ADDENDUM NO. 4

Reference: Gibson Science Center Addition
Southern Utah University – Cedar City, Utah
DFCM Project No. 07297730

Subject: **Addendum No. 4**

Sheet No.
AD04-SS13
 Sheet Reference
 SF103

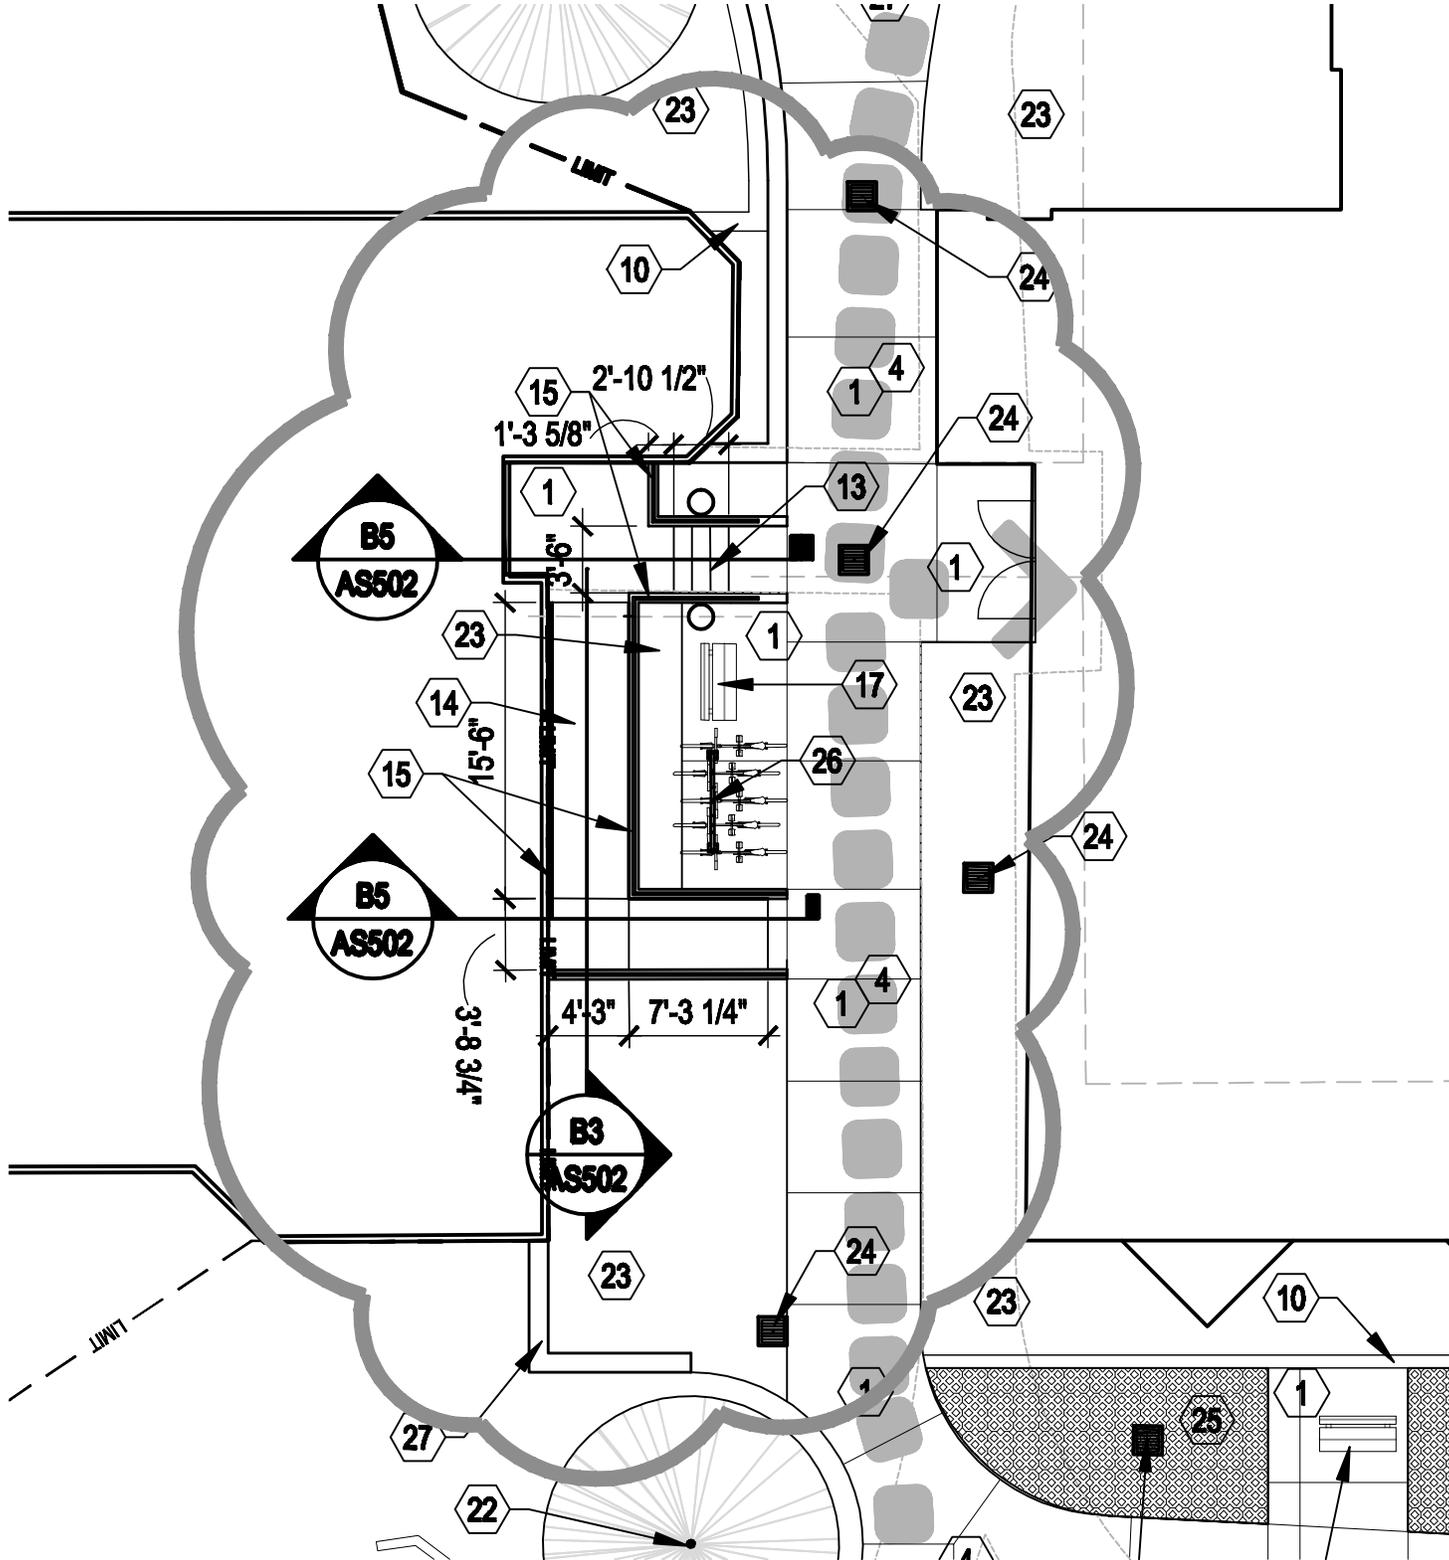
- S1.10 Re: SF103: Add detail cut A4/SF506 Typ./Sim. Drawing AD04-SS05 attached
- S1.11 Re: SF103: Revised detail cut references for two detail cuts near grid 4 and between grid D and Grid F. Drawings AD04-SS13 attached.

Sheet No.
AD04-AS01
Sheet Reference
GI011

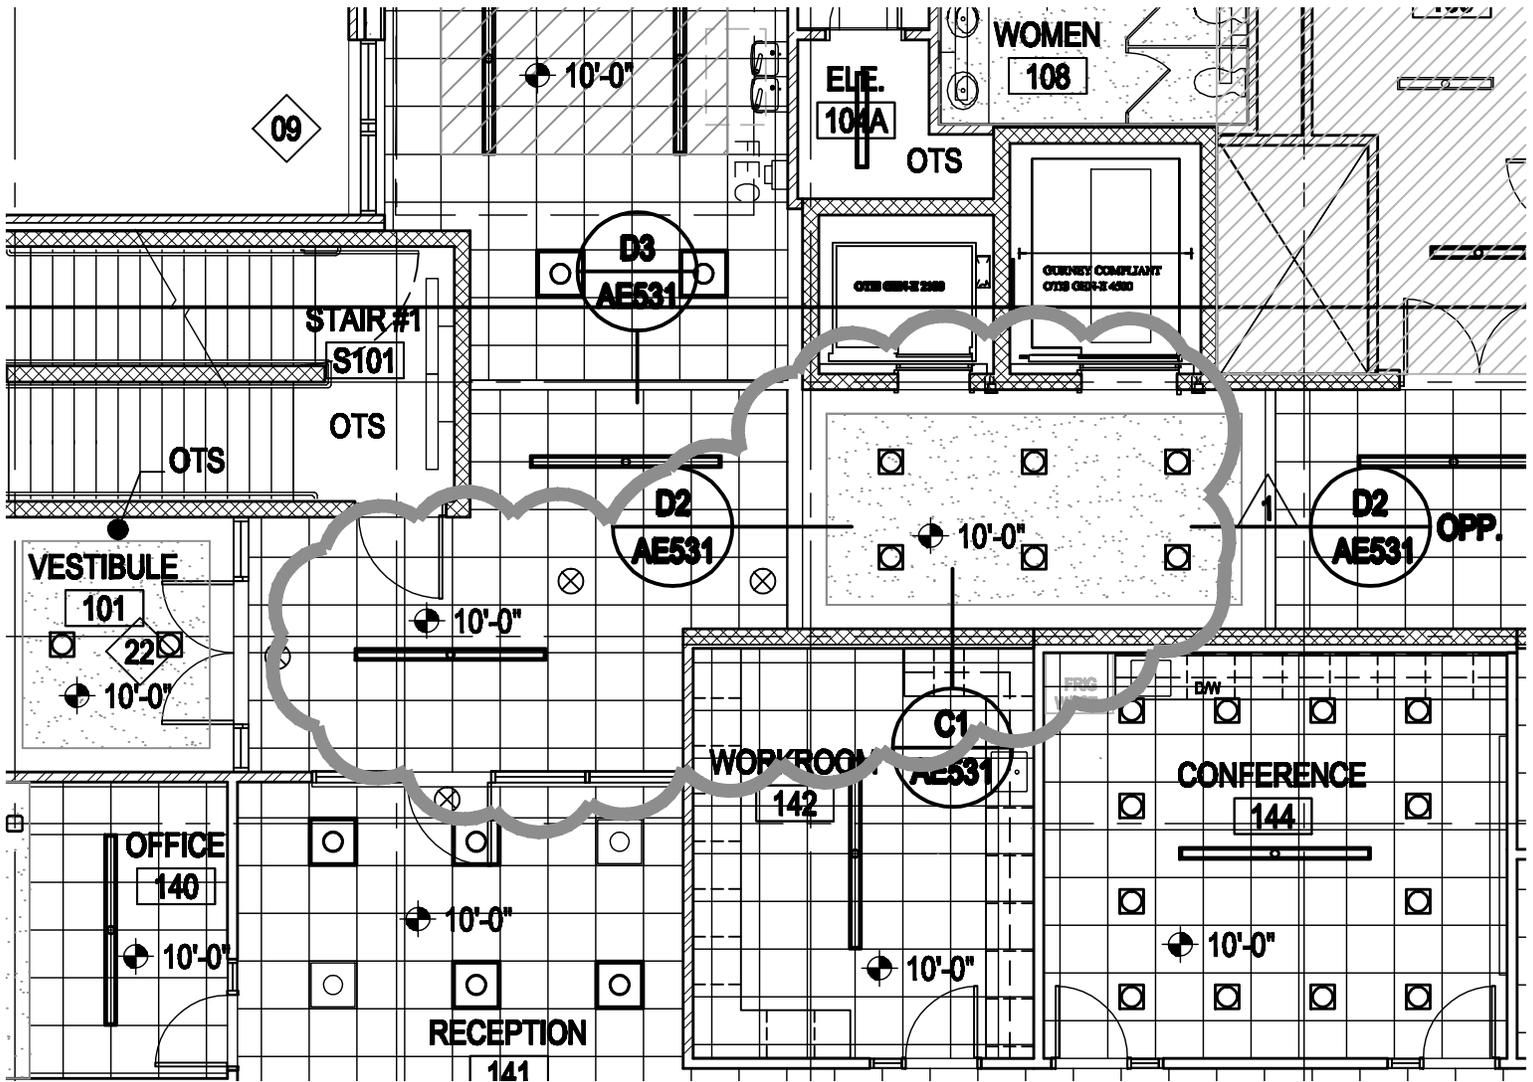
- A1.01 Re: GI011: Note area modifications for Classroom 127. Drawing attached AD04-AS01
- A1.02 Re: AC1B1: The ceiling assembly of room B08 shall be 1 hour rated construction.

Sheet No.
AD04-AS02
Sheet Reference
AC101

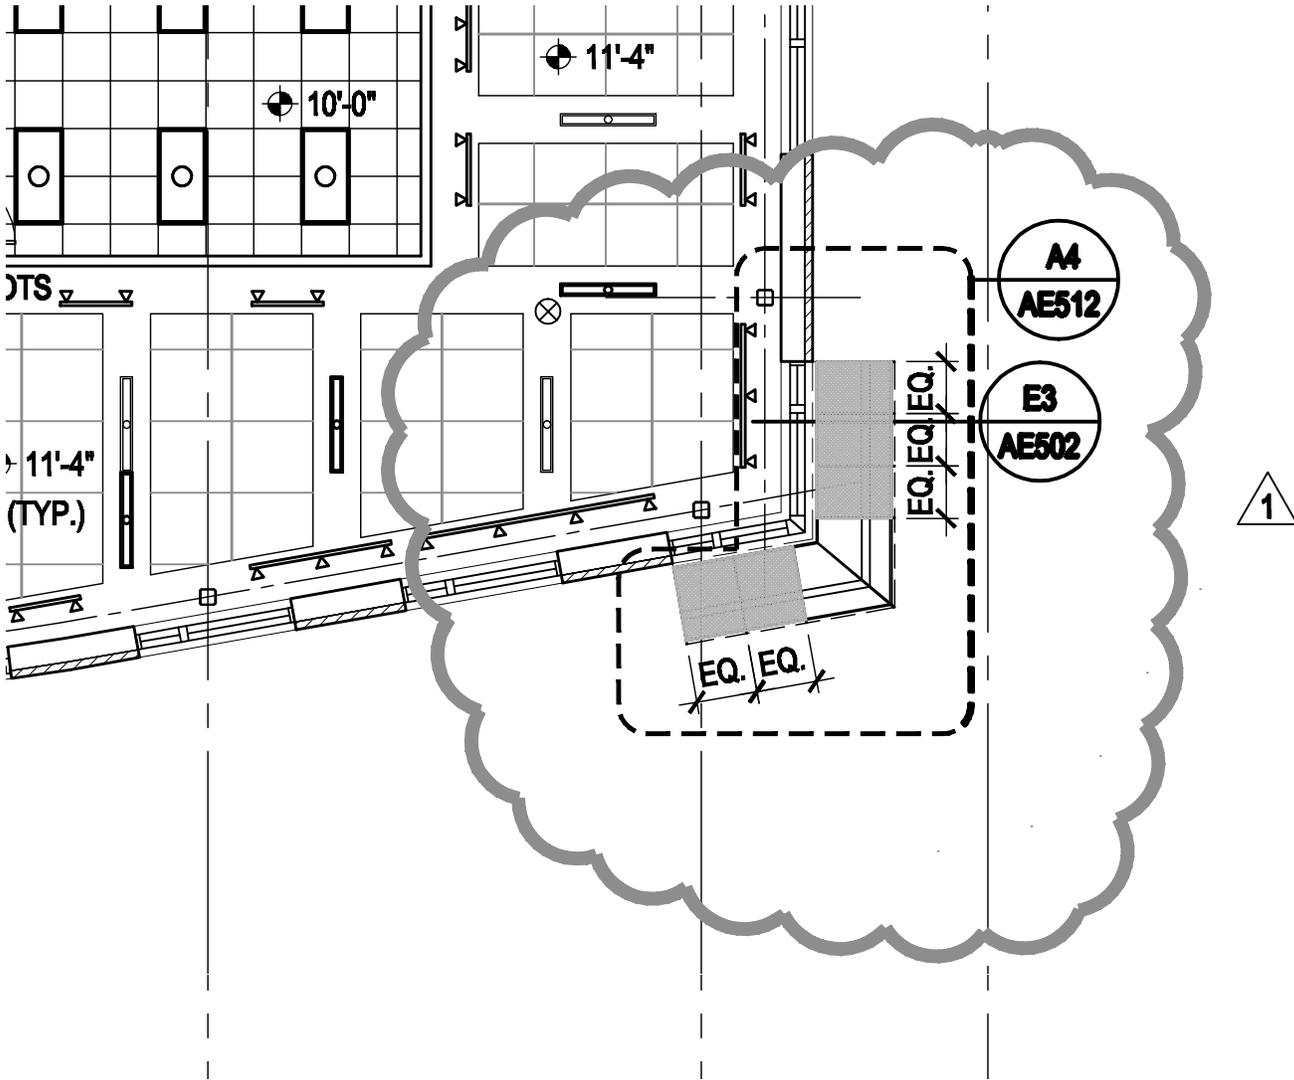
- A1.05 Re: AC101: Note corridor light fixture change to match lighting plan. Drawing attached AD04-AS02.
- A1.06 Re: AC101: Note new detail A4/AE512 referenced at the Museum window visor. Drawing attached A04-AS03.

Sheet No.
AD04-AS04
 Sheet Reference
 AC102

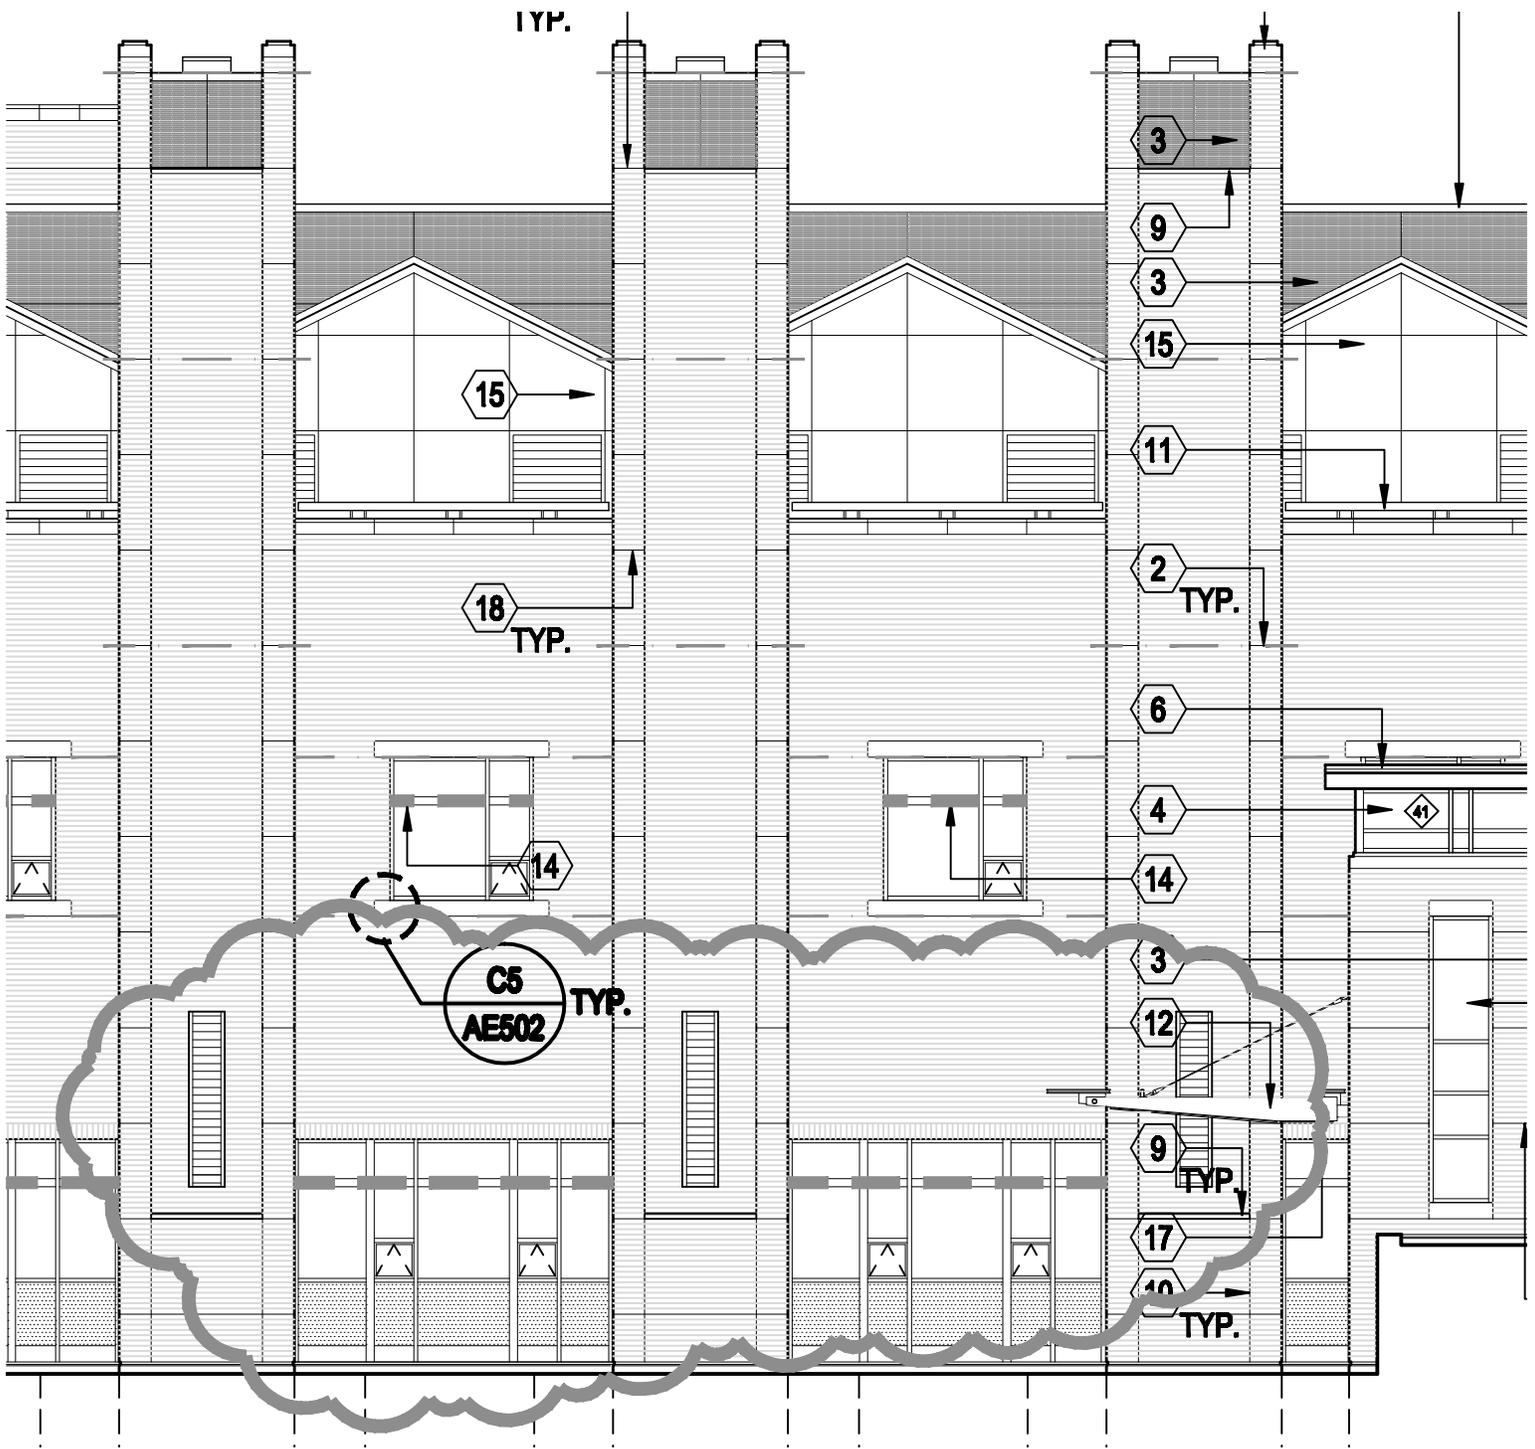
- A1.07 Re: AC102: Note ceiling systems for classrooms and corridor as indicated. Drawing attached AD04-AS04.
- A1.08 Re: AE201: Add louver to each exhaust shaft (3) total. Said louver shall receive a paint finish to match the curtain wall system. Drawing attached AD04-AS05.

Sheet No. AD04-M01
 Sheet Reference MH1B1

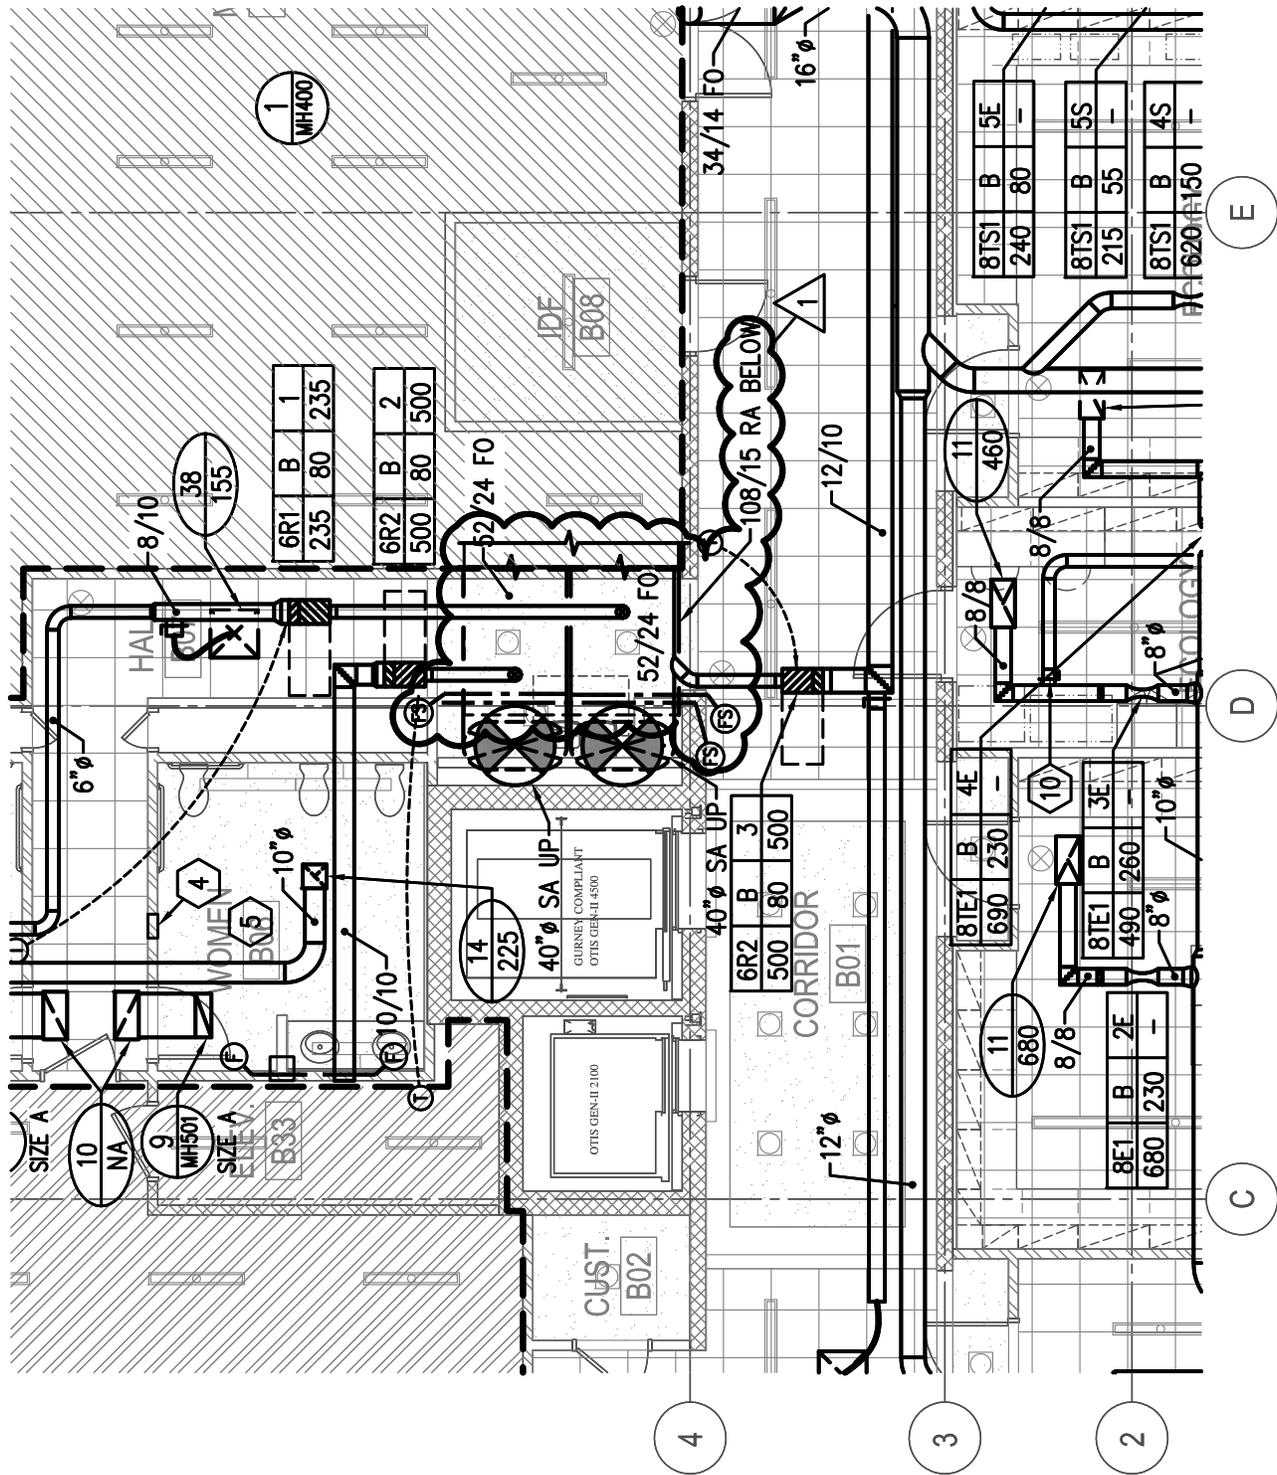
- M1.10** Re: MH1B1: Modified ductwork in exhaust shaft, keyed note 10. Showed return air duct between mechanical room and shaft. See AD04-M01&2.
- M1.11** Re: MH101: Modified ductwork in exhaust shaft, added louvers in exhaust shaft, clarified location of UH-2. See ADO4-M03.
